ADDENDUM NO. 1

Date of Addendum: 9/17/15

PROJECT NAME: Keegans Bayou WWTP Improvements

PROJECT NO: WBS No. R-000265-0101-4

AERATION BASINS OVERALL PIPING AND EQUIPMENT PLAN

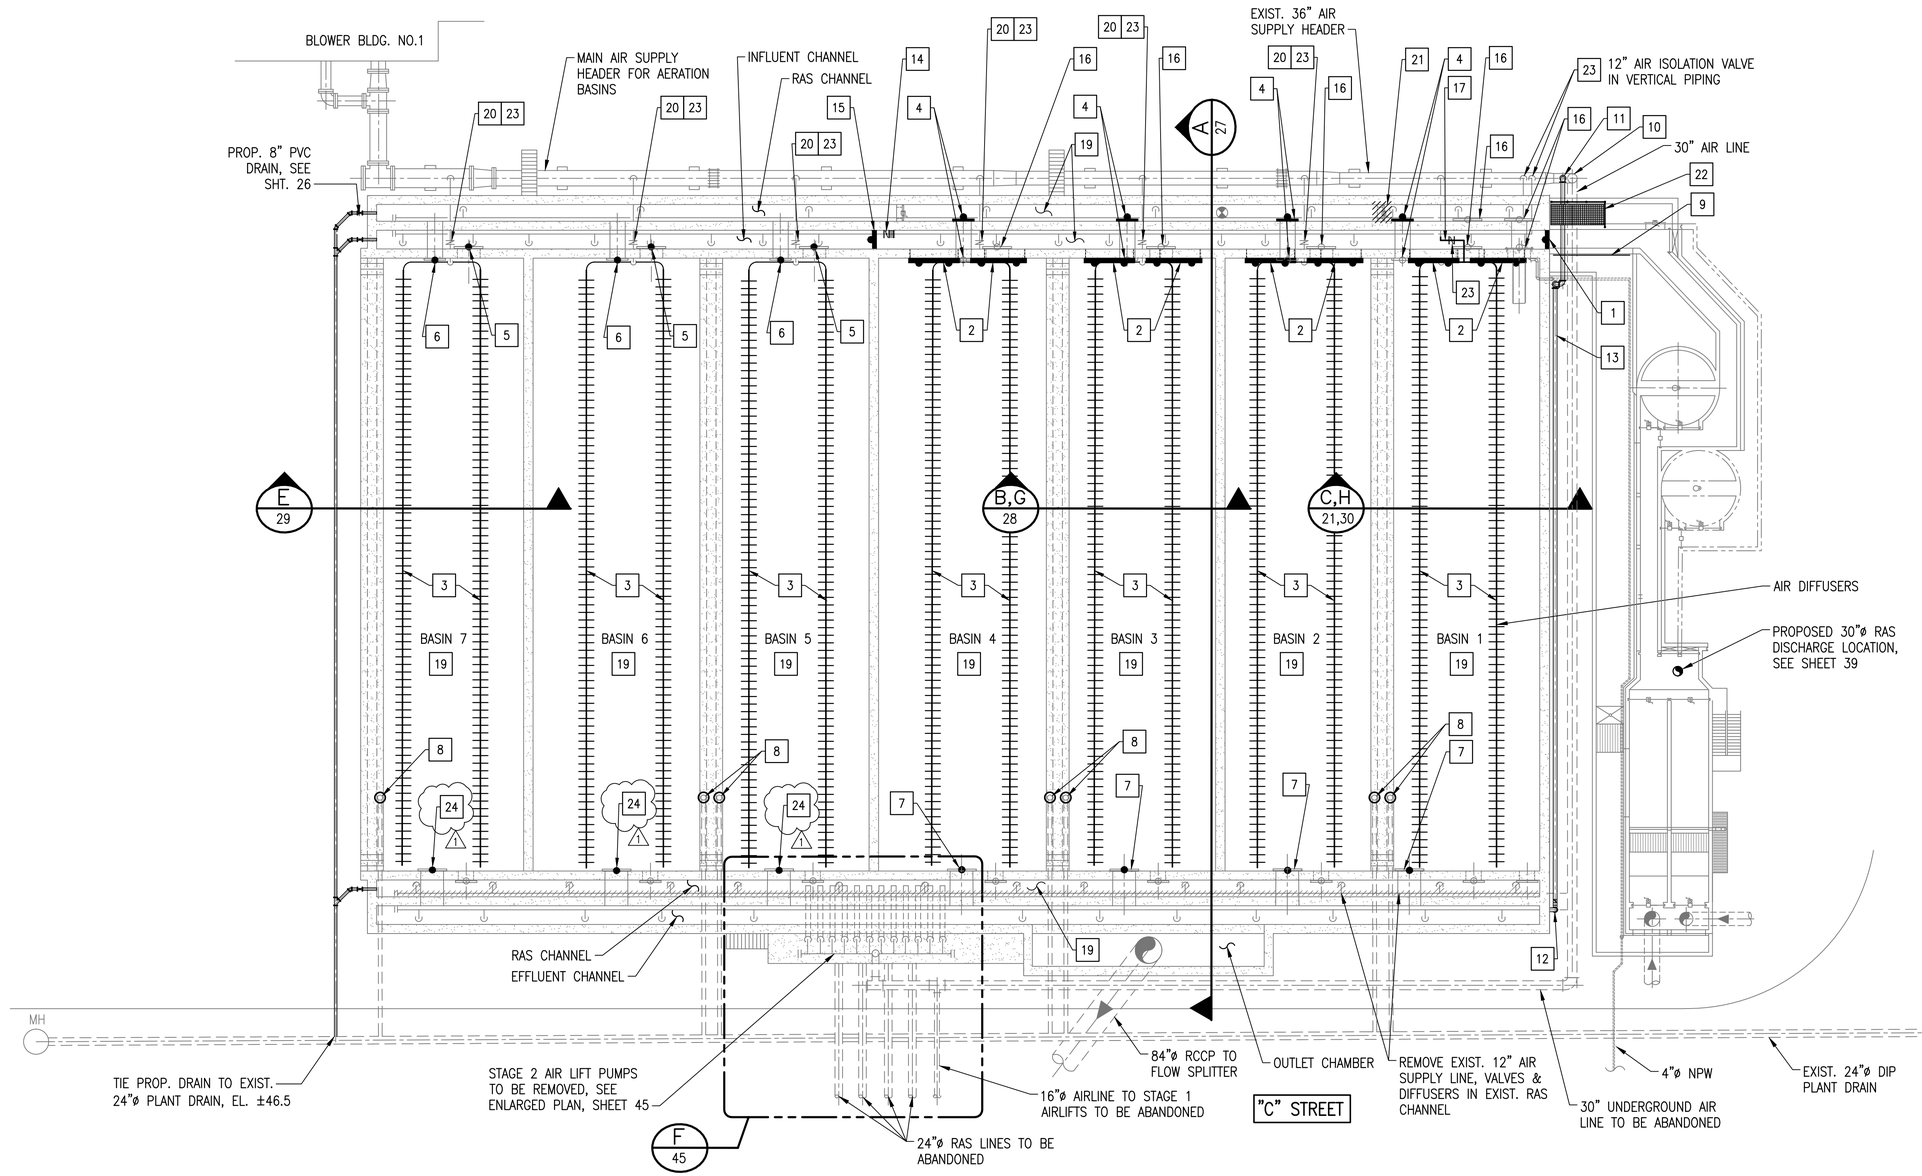
10. Replace Sheet 22: Revised Aeration Basins Piping & Equipment Schedule.

45. Question: On sheet 22 it states to repair the 48” x 48” sluice gates between the

RAS channel and Basins 1-7. What is the scope of repair we are to include in the base bid? These gates should probably just be replaced if they do not work. Currently there is an extra unit for 1 ea 48” x 48” sluice gate. This bid item should be increased to include more units. Answer: See revised Sheet 22 and 22A and Specification 00410B.

54. Question: Tag 18 on sheet 22: this note says to exercise 48" sluice gates and repair any that are nonfunctional. This is too open ended. What needs to be repaired? We need a description of repairs for vendor pricing and to ensure contractors bid the same scope. Answer: See revised Sheet 22 and 22A.

REV NO	DESCRIPTION	APP'D	DATE
1	GATE VALVE MODIFICATIONS, 4" DRAIN SLEEVE & VALVE

GATE SCHEDULE

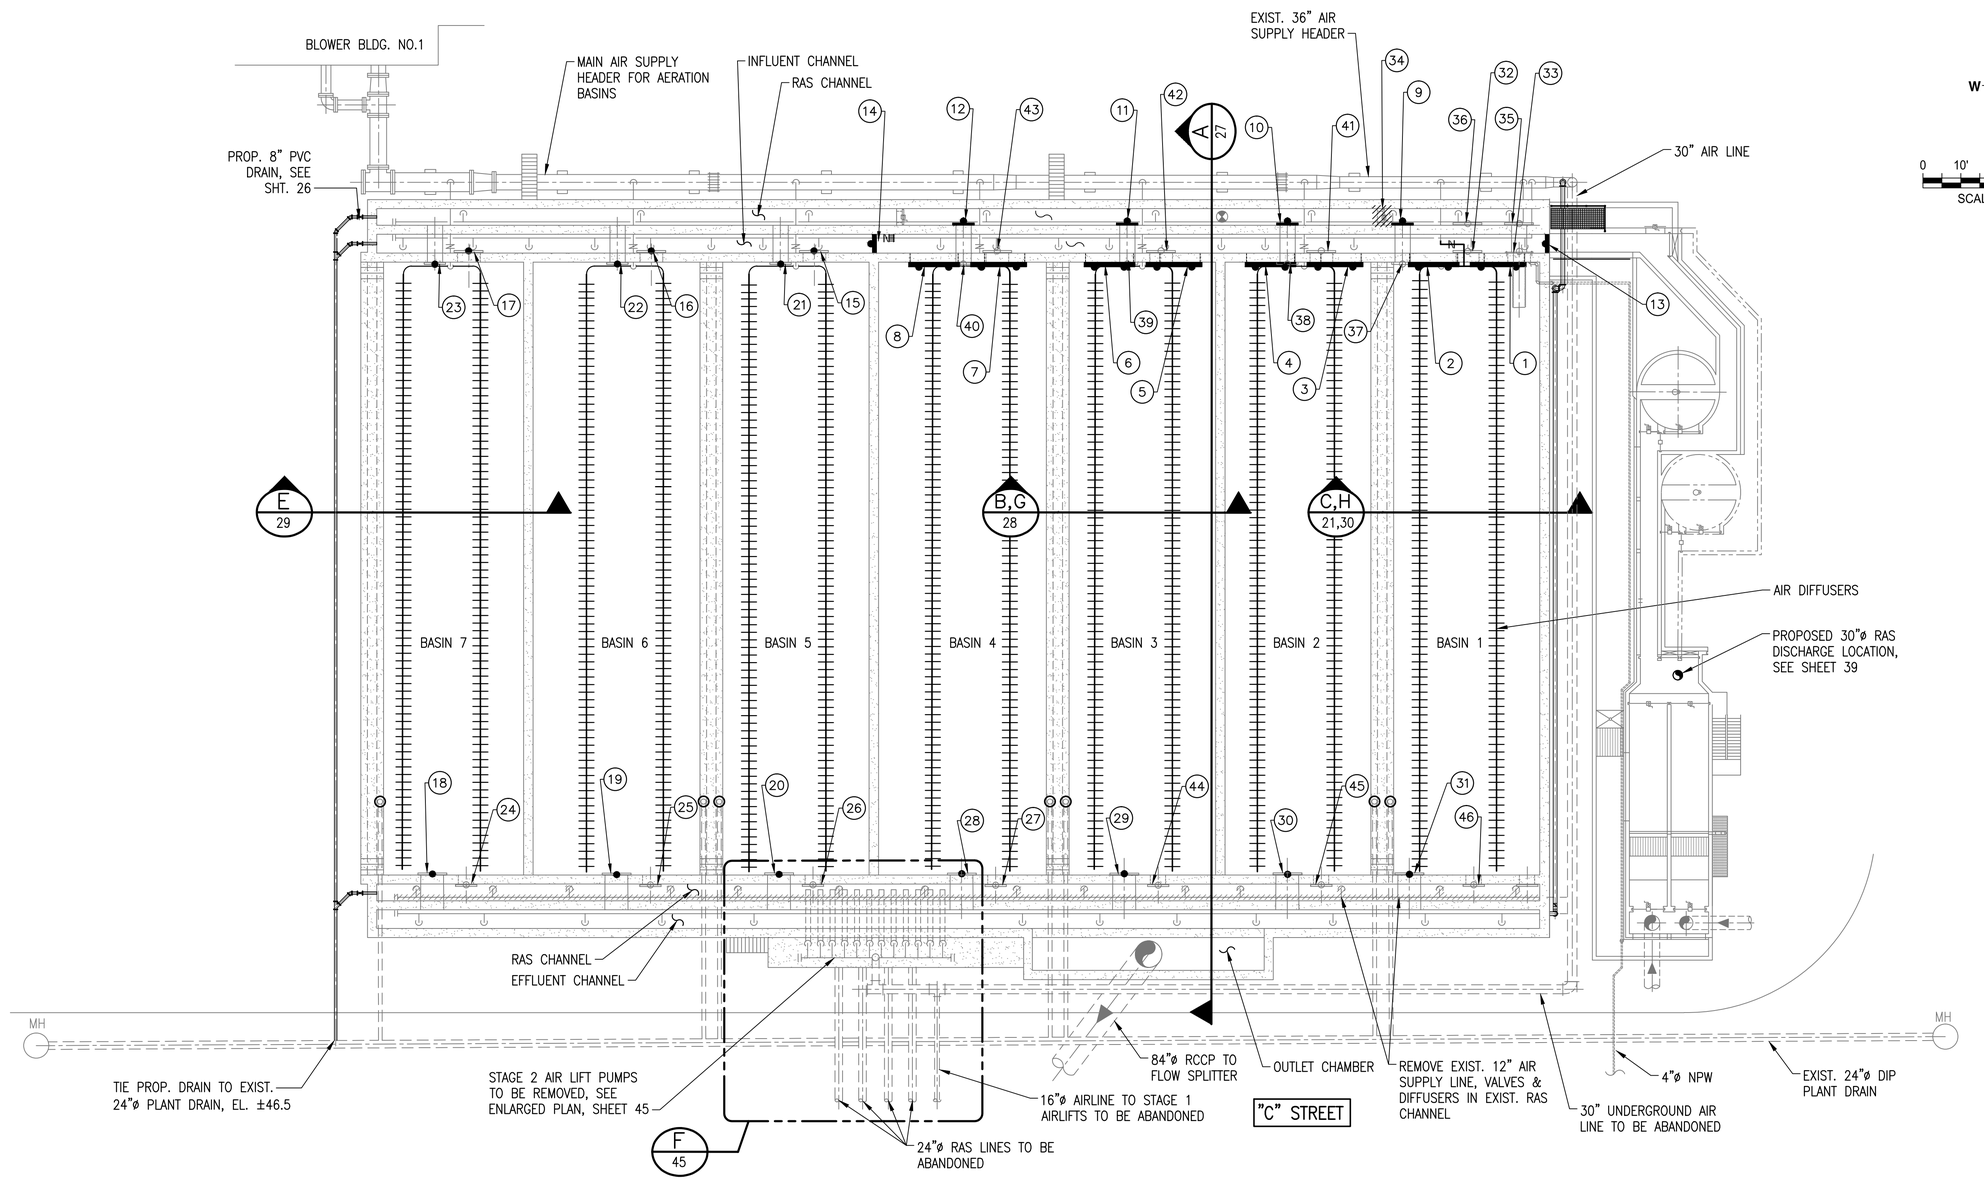
11. Replace Sheet 22A: Revised gate schedule.

48. Question: When told to replace stem and guides on page 22A, item #21-23, what spec section should we reference? Answer: See Specification Section 11285.

REV NO	DESCRIPTION	APP'D	DATE
1	GATE VALVE MODIFICATIONS

WBS NUMBER	
R-000265-0101-4	
DRAWING SCALE	
AS SHOWN	
CITY OF HOUSTON PM	
BILL ZOD, P.E.	
SHEET NO. 47 OF 185

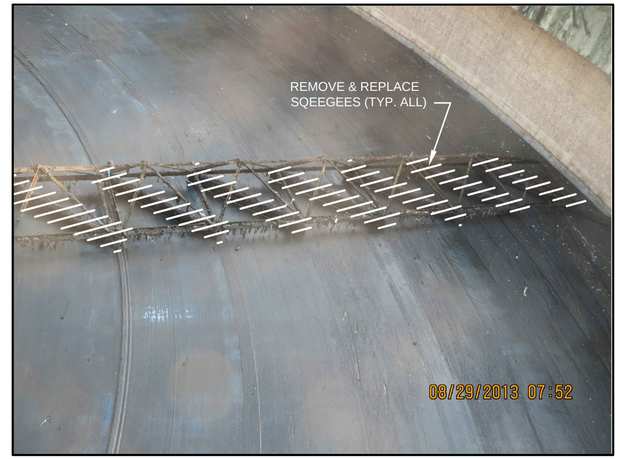
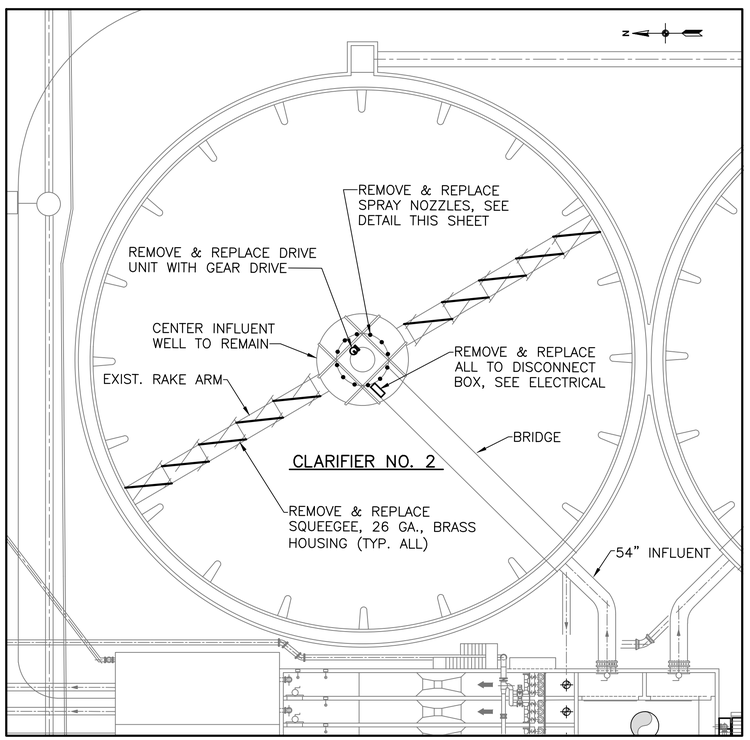
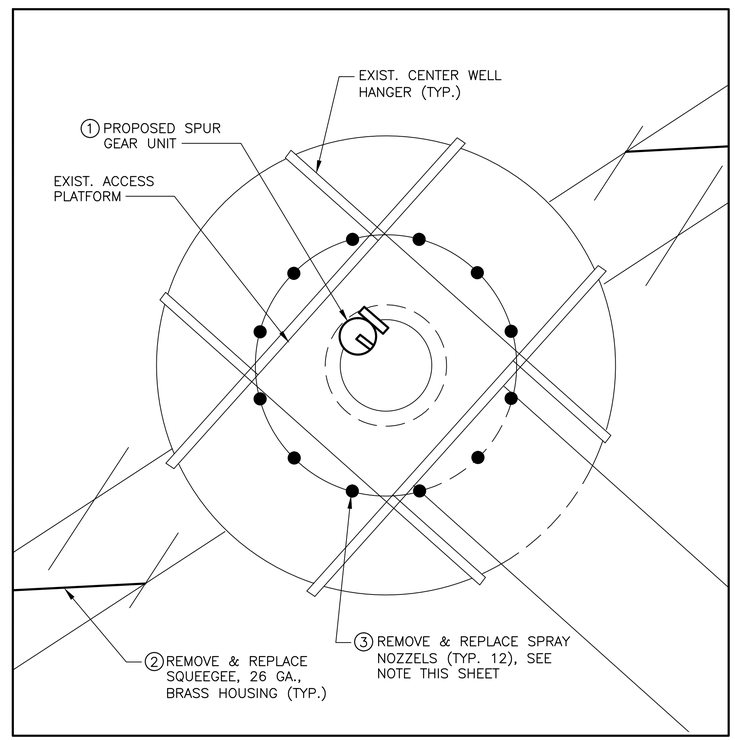
12. Replace Sheet 47: Modified note for additional information on spray nozzles.

30. Question: Need more information on the spray nozzles i.e. gpm, spray pattern (cone, flat, mist), pressure, etc. Answer: See revised Sheet 47. For clarification, the water pressure is 90 psi.

REV NO	DESCRIPTION	APP'D	DATE
1	REVISED SPRAY NOZZEL NOTE

DRAIN VALVE SECTION

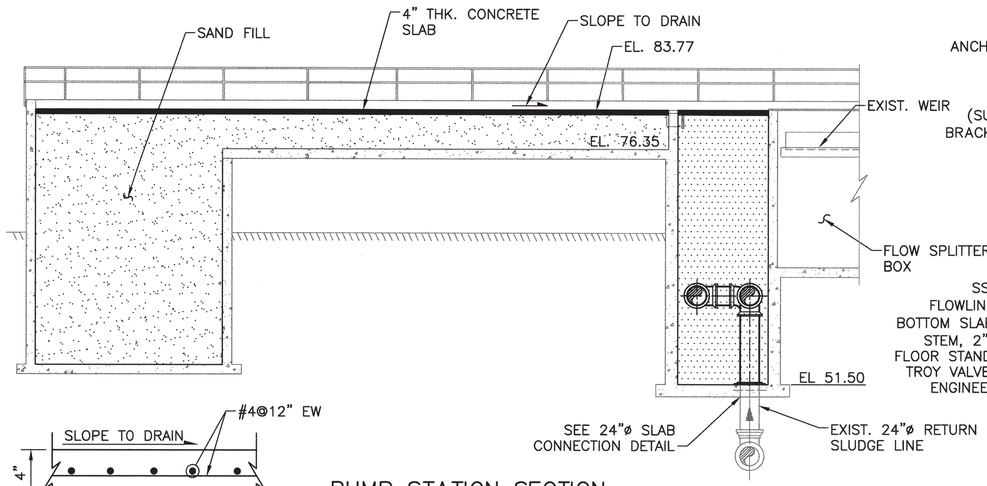
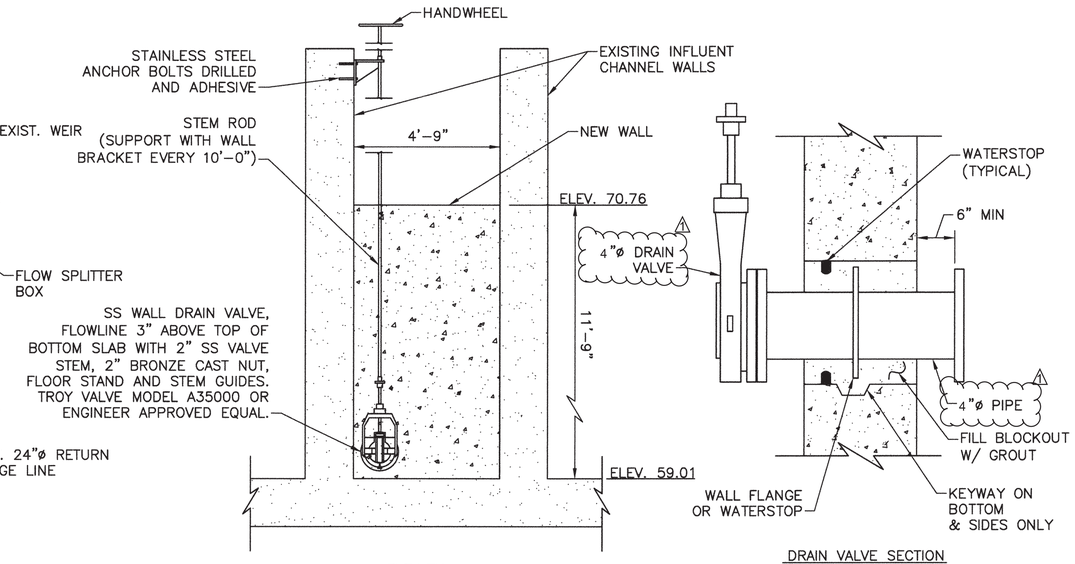
13. Replace Sheet 84: Troy drain valve shall be 4” instead of the 8” called out on the drawing.

REV NO	DESCRIPTION	APP'D	DATE
1	DRAIN VALVE MODIFICATION
